Wollongong Local Planning Panel Assessment Report | 5 September 2018

WLPP No.	Item 1
DA No.	DA-2017/1577
Proposal	Mixed use development -demolition of existing structures and the construction of a mixed use development consisting of 2 commercial tenancies, 35 apartments over basement parking for 50 cars
Property	Lot 11 DP 1171213, 27 Flinders Street, WOLLONGONG NSW 2500
Applicant	Arthur Zougis – Artro Management
Responsible Team	Development Assessment and Certification - City Centre Team (NL)

ASSESSMENT REPORT AND RECOMMENDATION

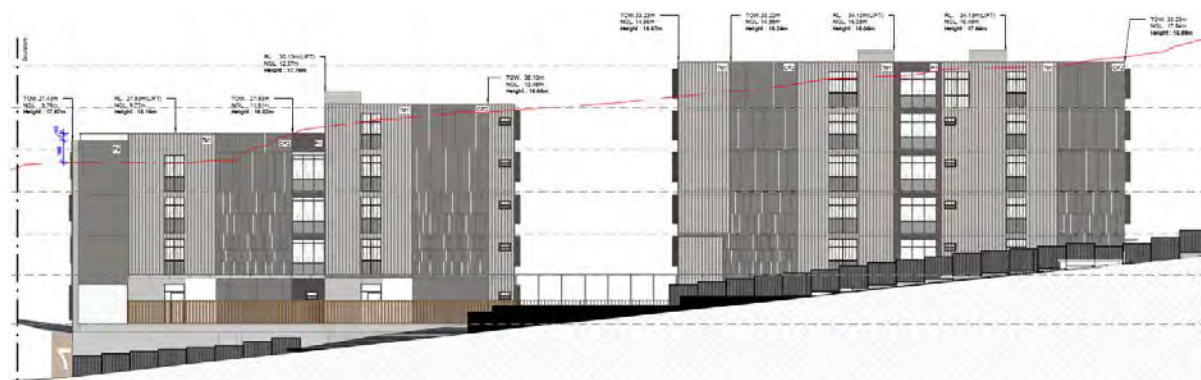
The building height exceeds the maximum of 16m permitted for the site by approximately 2.5m as shown in Figure 2 below.

Development departure	1. Clause 4.3 Building Height: The maximum height permitted is 16m and the building reaches a height of approximately 18.9m which results in a variation to the height control to a maximum of 18% to the numeric standard.
Is the planning control in question a development standard	Yes

Height Blanket Volume Diagram
1 : 100

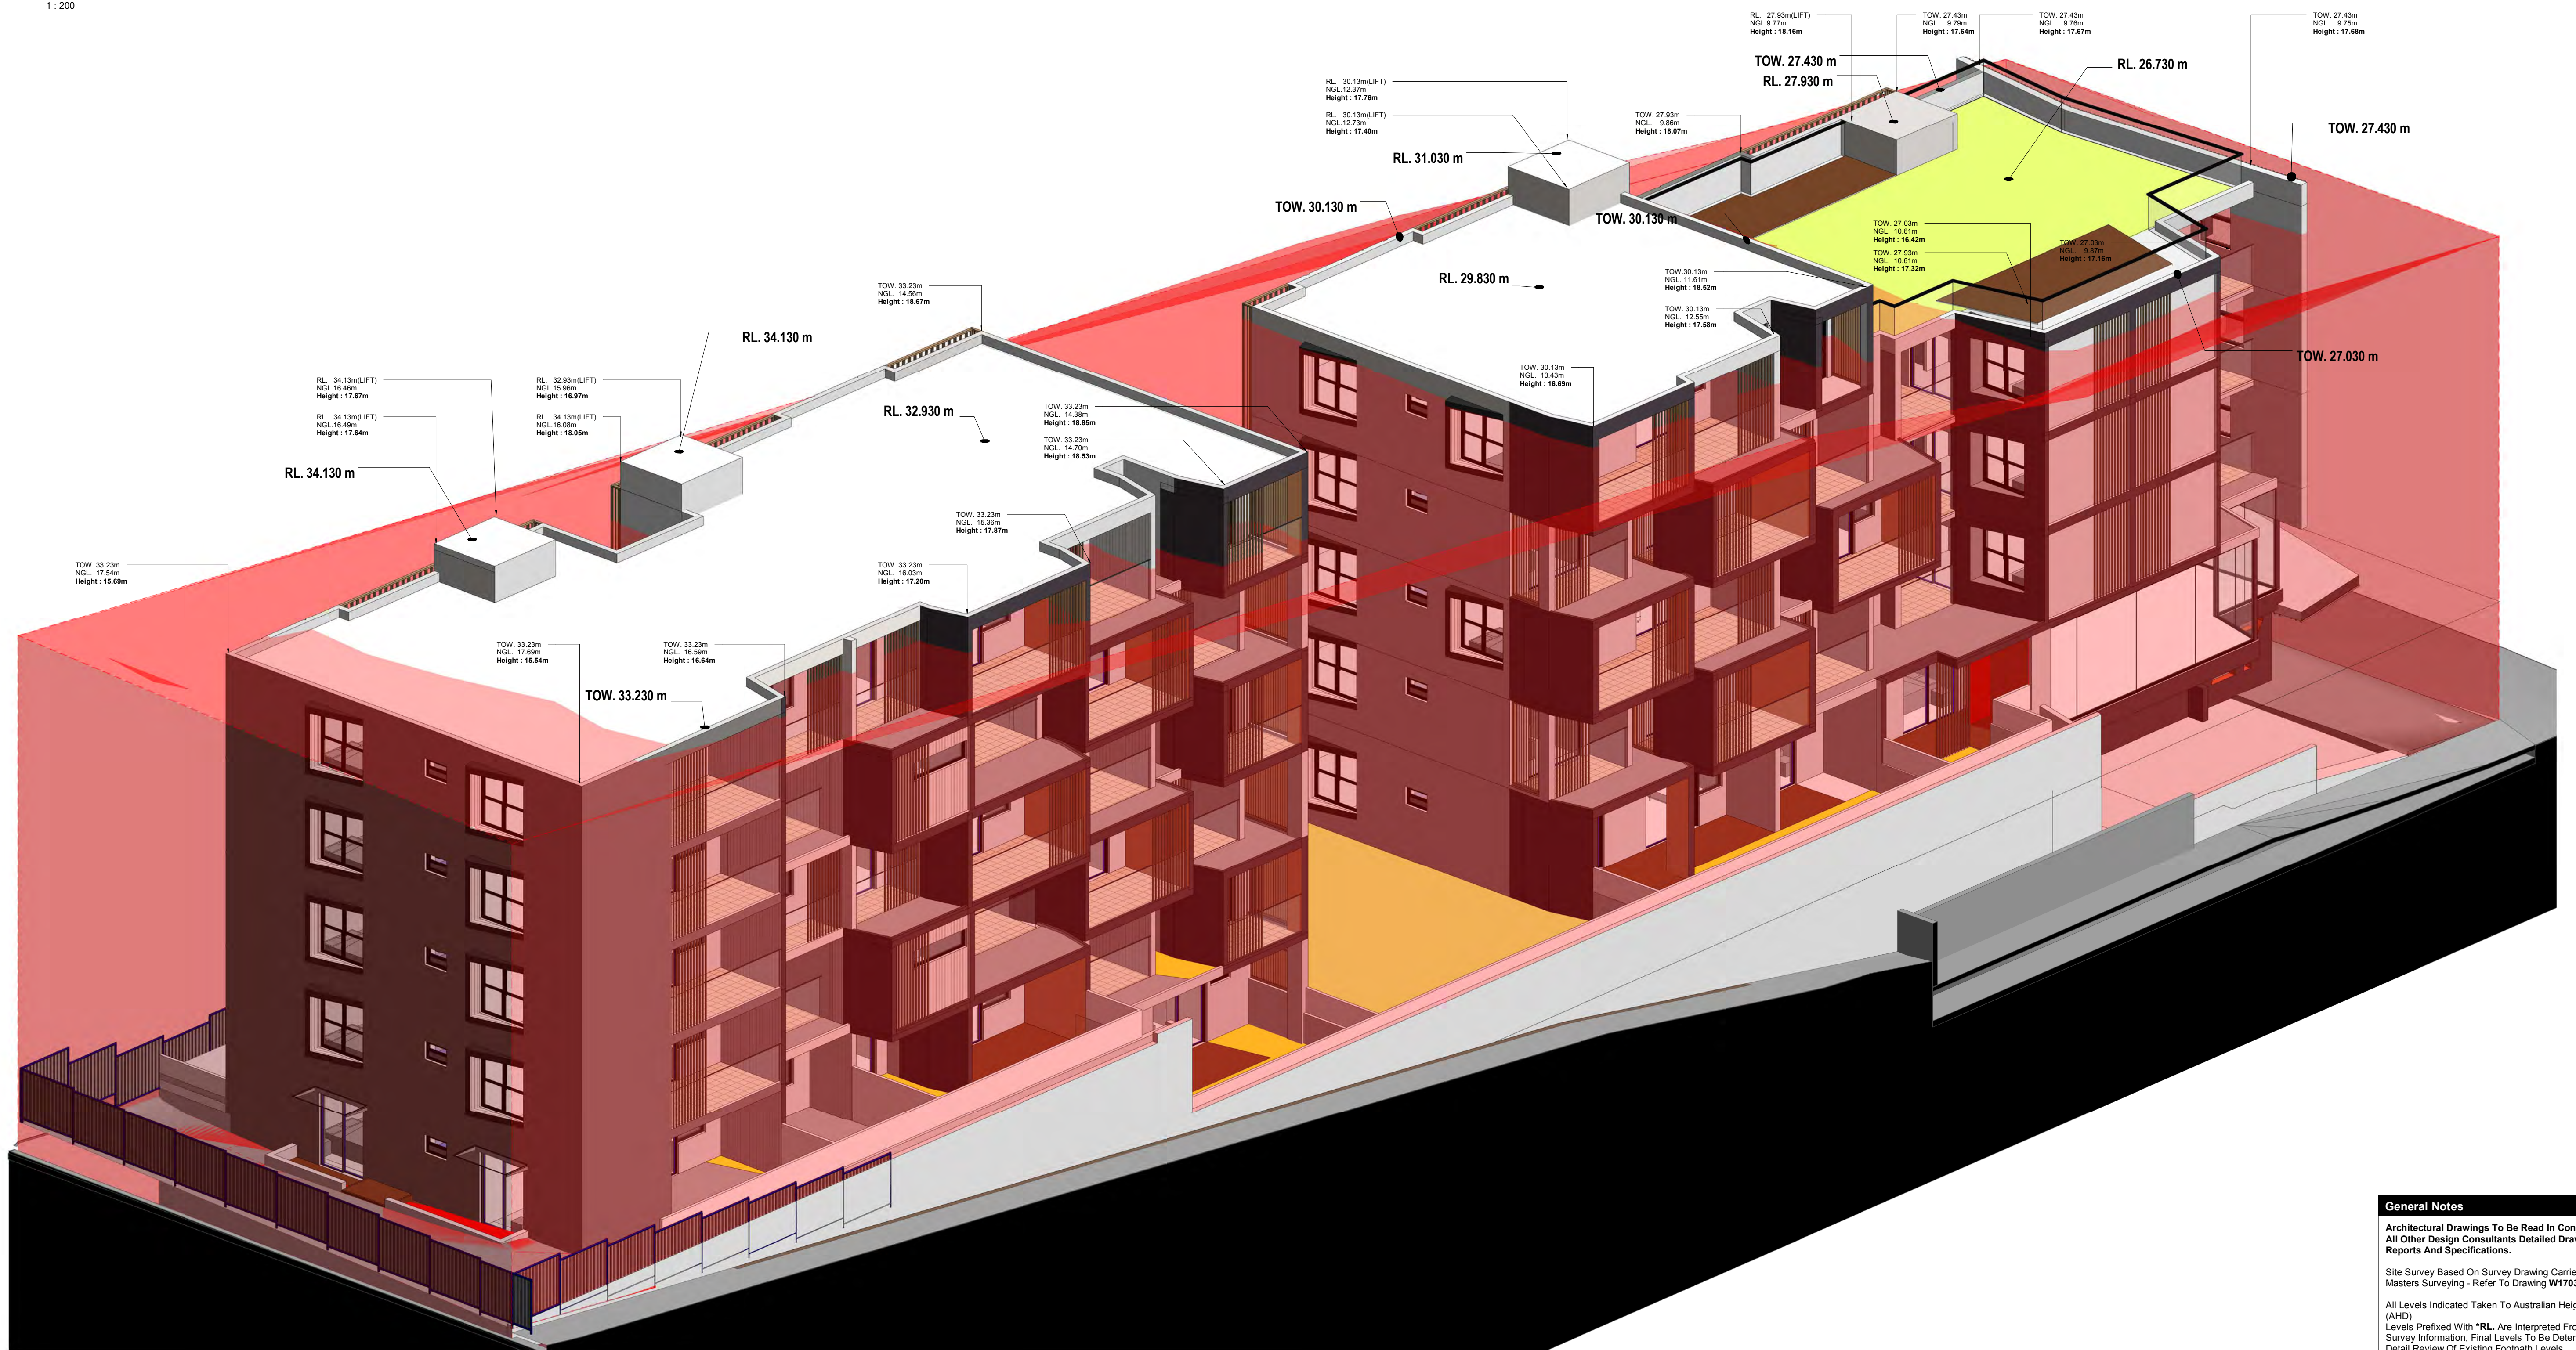
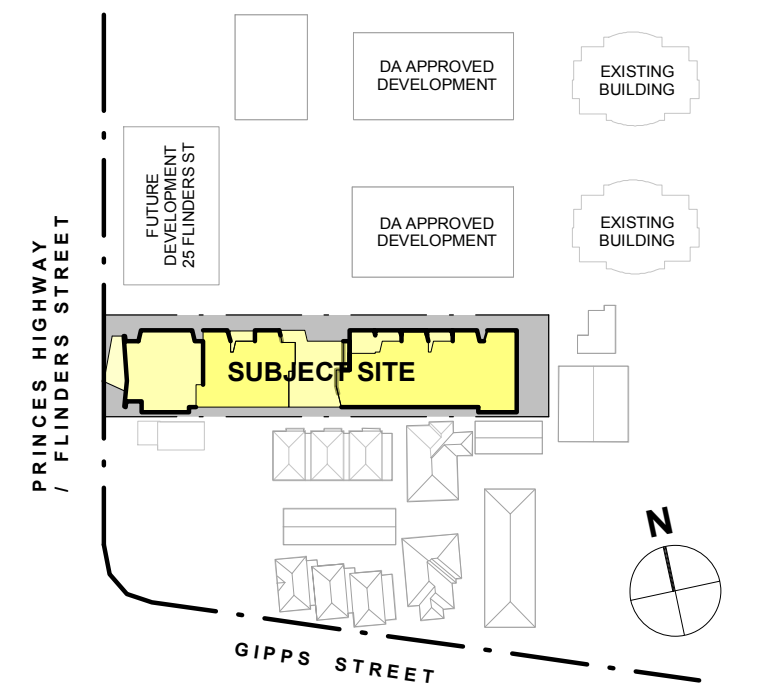
No, it is not considered that there are sufficient environmental planning grounds to justify contravening the standard.
